*Fermi 2*  
*Response to Recommendations*  
*from the Duke Power Company*  
*Final Assessment of Construction*

FERMI 2  
RESPONSE TO RECOMMENDATIONS  
FROM THE DUKE POWER COMPANY  
FINAL ASSESSMENT OF CONSTRUCTION

DETROIT EDISON  
SEPTEMBER 1984

FIGURE 1-1

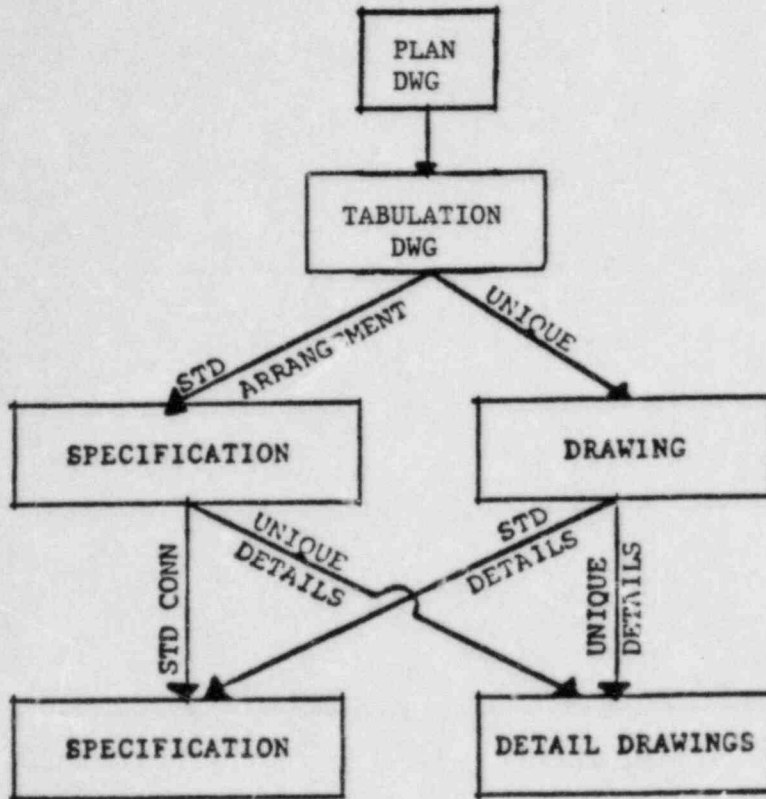
Provide an understandable method for determining what changes have been made in the design drawings of cable tray hangers. (Ref. Section 3.1.2.)

Cable tray and conduit supports are acceptable and will serve their intended function. Detroit Edison needs to provide an understandable method for determining what changes have been made in design drawings for the individual cable tray supports.

is to be found. For standard hangers, this is in the electrical specification; for unique hangers, the reference is to a drawing. Both of these documents, in turn, refer to the location of details and connections. If standard connections are utilized, they are as shown in the specification; if the connections are unique, they are shown in the hanger drawing. (This drawing process is illustrated in Figure 1-1.)

The project's objective is to have tray support design change documents incorporated in the original drawings and specifications at the time of turnover of design documents to Nuclear Production. All change paper, including design change packages with the associated interim design change documents, will be incorporated in these base design documents. When design change documents are all incorporated into the base design documents, there should be no difficulty determining the final design configuration of the supports.

The design group is currently preparing a design document package to provide a "roadmap" through the design calculations for tray hangers. As an added measure, Edison will also add appropriate details to this package to include a "roadmap" through the related drawings and specifications. This package will include directions for obtaining additional records, work packages, etc., and will provide additional detail and information on the as-built configuration of the hangers.

FIGURE 3-1

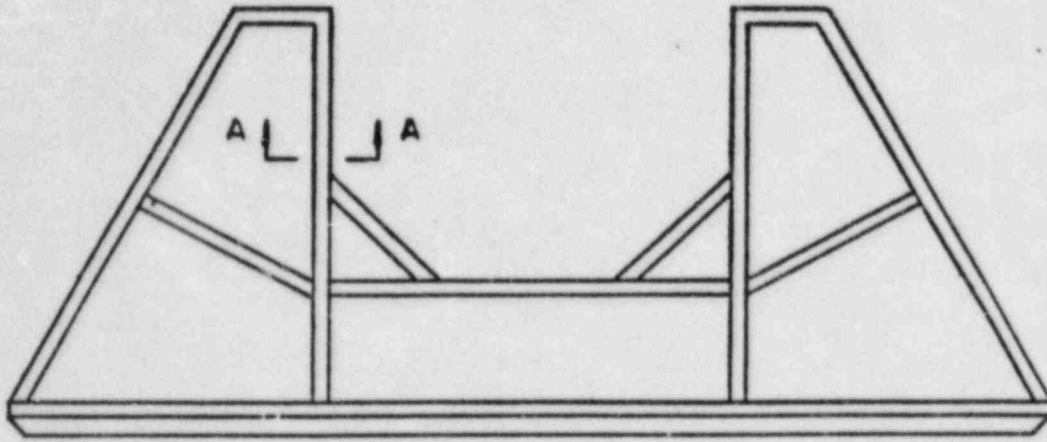
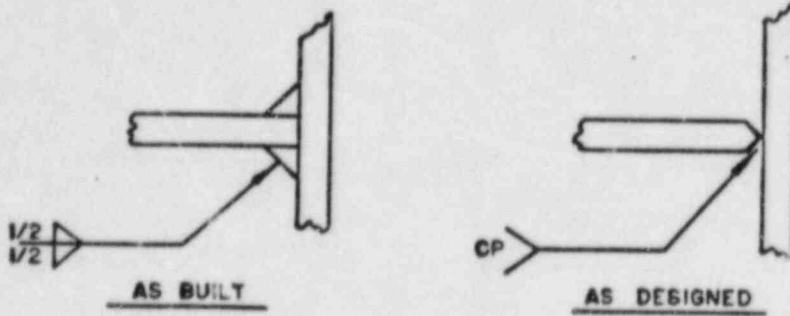
Perform an engineering analysis of pipe whip restraints to determine if 1/2" fillet welds are acceptable for GE supplied restraints which are required to have full-penetration welds. Walkdown the systems containing pipe whip restraints to verify all of those which have been removed for construction purposes have been replaced. (Ref. Section 3.1.4.)

- (1) Perform an engineering analysis to determine if 1/2" fillet welds are acceptable for GE-supplied whip restraints which were required to have full-penetration welds.
- (2) Walkdown systems containing pipe whip restraints to verify field locations versus drawing locations and observe completeness of installation (i.e., no disconnected or missing parts).

Figure 3-1 shows the pipe whip restraint frame structure and, typically, the weld areas in question.

GE was informed of the detail in which the pipe whip restraint structure does not appear to conform to the GE drawing. After a thorough investigation, GE responded that the nonconformance does not affect the required structural capacity of the restraint. GE indicated that the restraint can withstand loads higher than the Fermi 2 design loads. GE concluded, therefore, that the 1/2-inch fillet welds are adequate and that an engineering change notice would be issued indicating that either 1/2-inch fillet welds or full-penetration welds are acceptable in the manufacture of the pipe whip restraints.

FIGURE 4-1

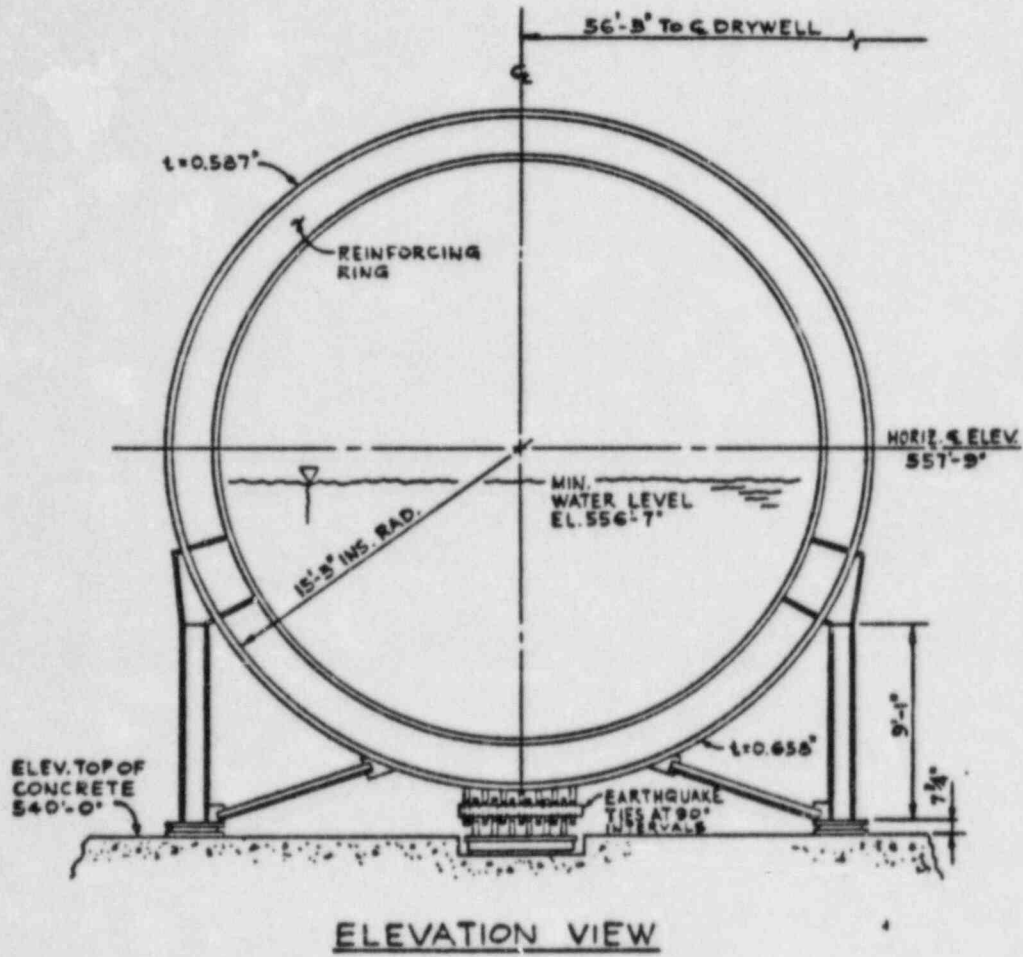
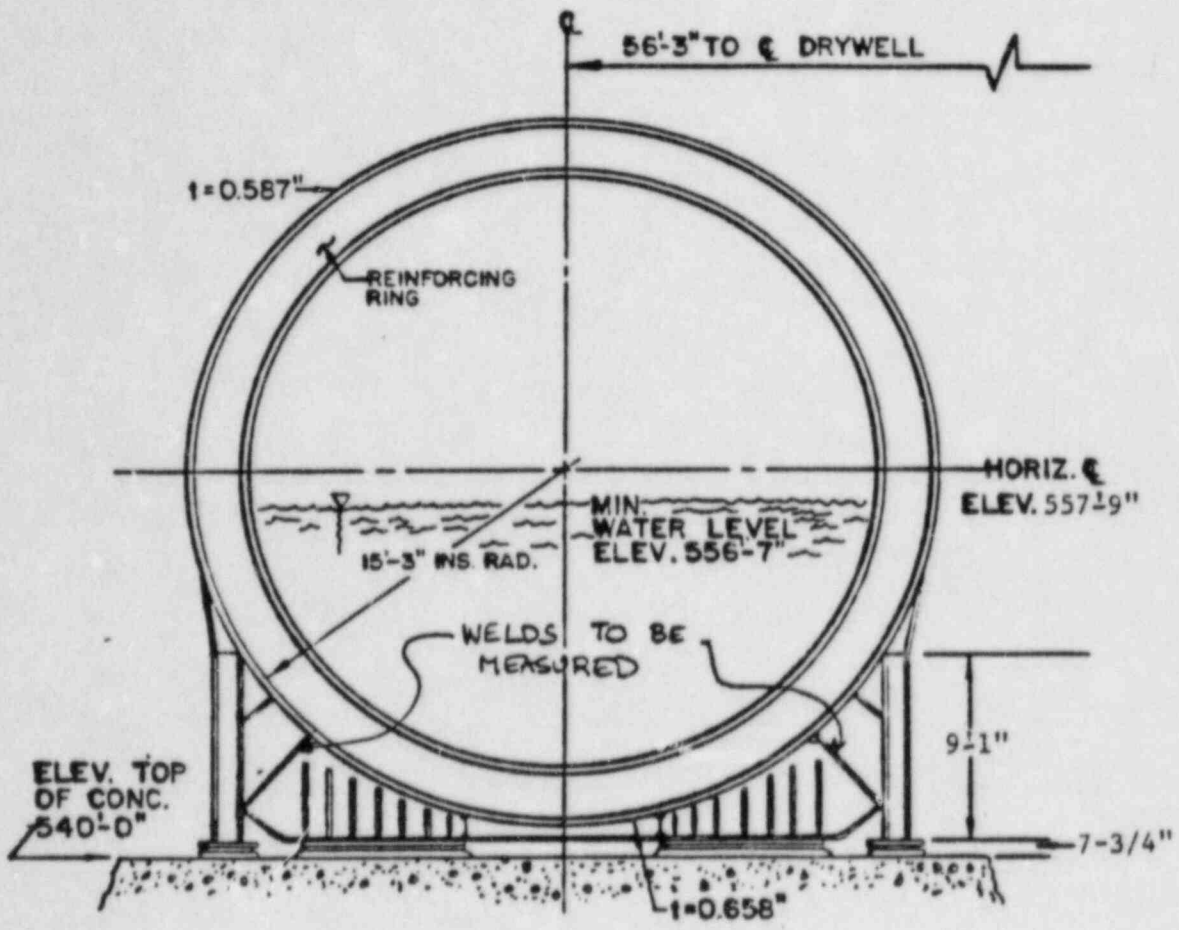
The original installation of these supports has seen two major modifications. Three different sets of drawings have to be used when inspecting the supports.

Due to the difficulties encountered during this evaluation and potential difficulties on modifications to these supports after operation, it is recommended that Detroit Edison review the several sets of revisions to the torus support drawings to determine that the as-built condition meets design requirements.

The original configuration of the torus support and its configuration after modifications are shown in Figures 4-1 and 4-2, respectively.

To resolve the confusion due to the several sets of drawings, Edison plans to incorporate all design change documents posted against the Nutech design drawings. Edison will also revise the CBI drawings and Nutech drawings to add cross-references to the torus drawings.

Edison will also measure the weld sizes at the interface of the first and second modifications to verify that the designer's intent was constructed. Any undersize welds will be reported on nonconformance reports for Engineering disposition.

FIGURE 6-1

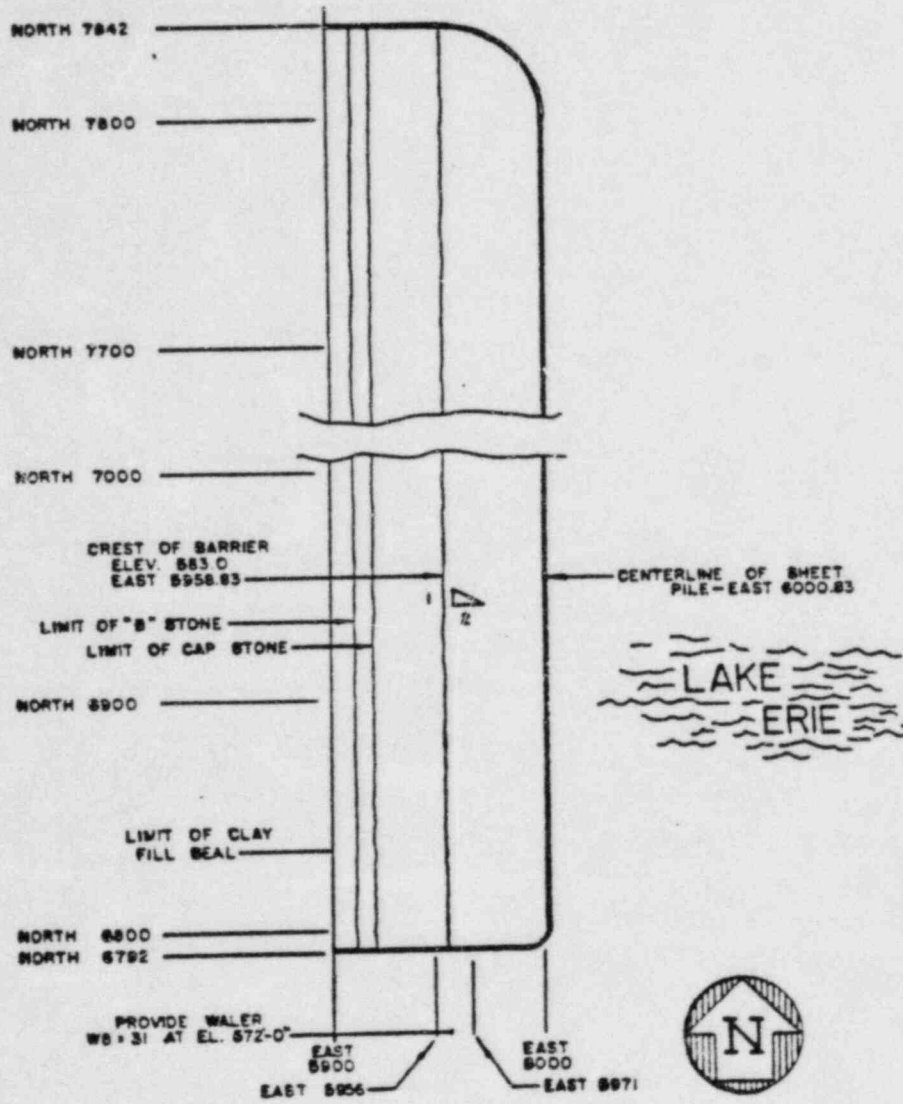
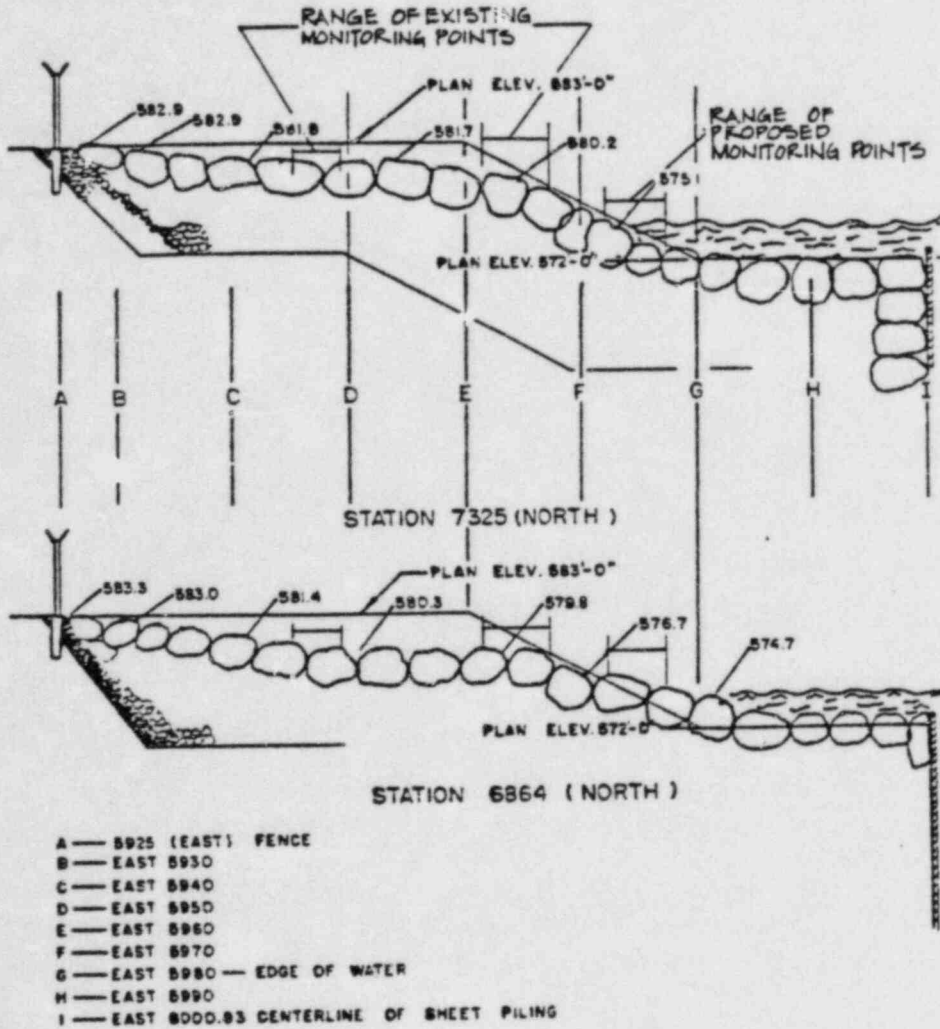
After the barrier construction, it was noted that the profile at the south end of the barrier did not match the design. Surveys at 100-foot intervals were taken and a deviation disposition request issued. It was dispositioned by Engineering to use-as-is and to add the as-built elevations to the design drawing.

Mr. Noble evaluated the as-built elevations with respect to the design conditions and has determined that the shore barrier is capable of withstanding the probable maximum meteorological event. The observed and surveyed low areas of shore barrier cap stone will not adversely affect the shore barrier's ability to maintain the integrity of the plant site at El 583'.

Edison will add six new monitoring points on the slope of the shore barrier. The points will be located at approximately the same north-south grid as the existing 12 monitoring points. The east-west location will be at approximately grid line E5975, which is in the lower third of the slope. Six of the existing monitoring points are on the upper third of the slope. These twelve monitoring points will provide adequate information to monitor the stability of the shore barrier slope. Mr. Noble concurs with the location of these points.

FIGURE 11-1  
DRYWELL PENETRATION

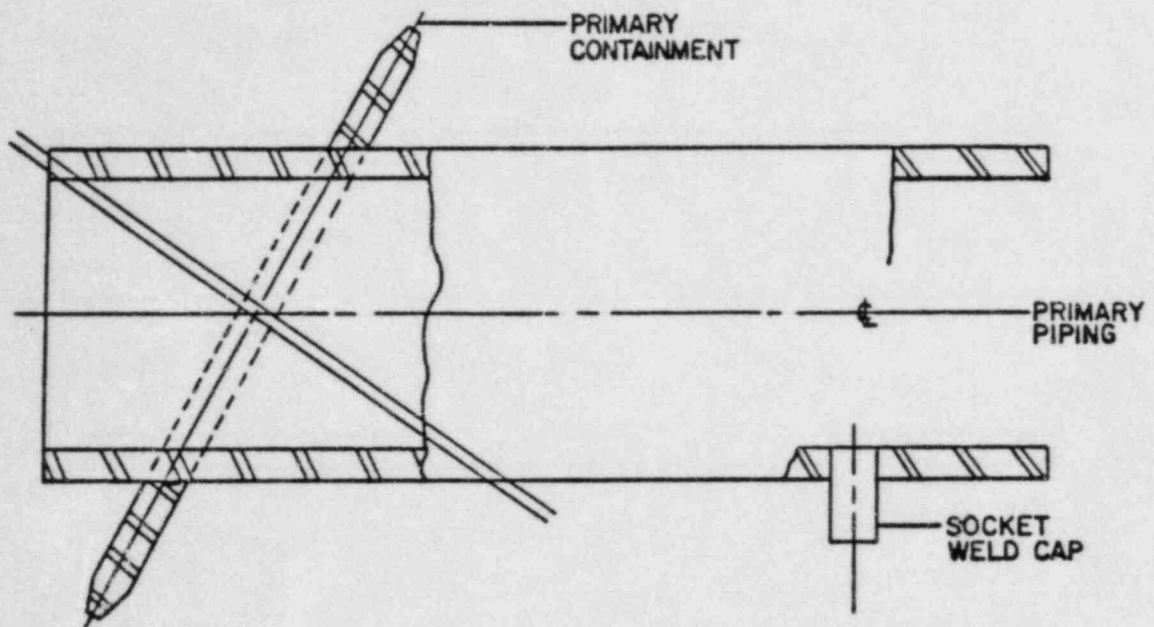
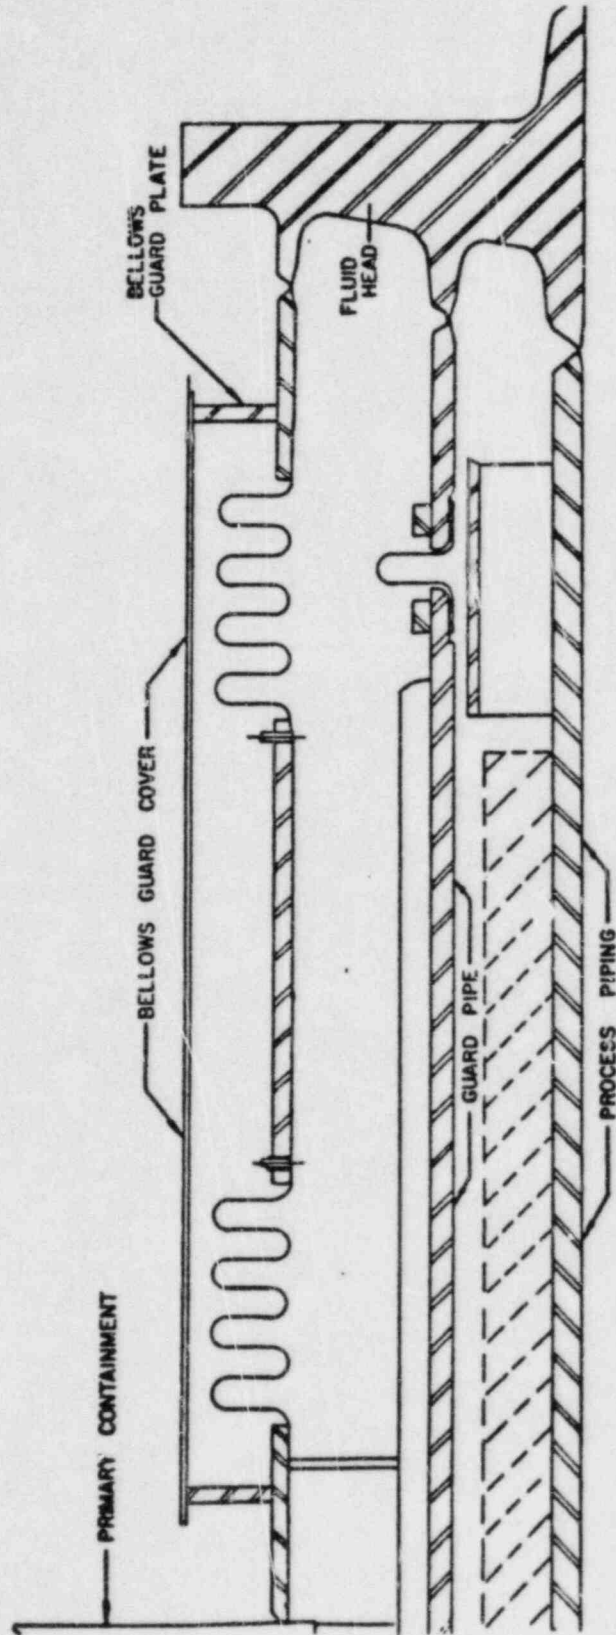
Mechanical penetrations were supplied and installed in the drywell with small diameter connections for draining and blowing out the larger penetration piping. Figure 11-1 illustrates the drywell penetrations. The small diameter connections to the penetration must be plugged before the integrated leak rate test is performed; otherwise, primary containment will not hold pressure as is required by the test.

Also, some of the mechanical penetrations of the drywell have expansion bellows to allow for movement of attached piping relative to the connected primary containment shell. Expansion bellows type containment penetration is shown in Figure 11-2. Figure 11-2 shows a protective covering over the bellows section of the penetration assembly. Because local leak rate testing is presently being done to prepare

In June 1984, all penetrations were visually inspected for completeness by the System Completion Organization. Several punchlist cards were written to plug all open small connections on the drywell penetrations. A reverification that all penetration small connections have been plugged was performed in July 1984. Furthermore, the integrated leak rate test of primary containment will provide final assurance that all openings have been closed. Upon completion of local leak rate testing and the successful completion of the integrated leak rate test, all protective covers for the bellows type penetrations will be finally installed and bolted up. This activity has been made a punchlist item to provide added assurance this item will be resolved and the covers properly installed.
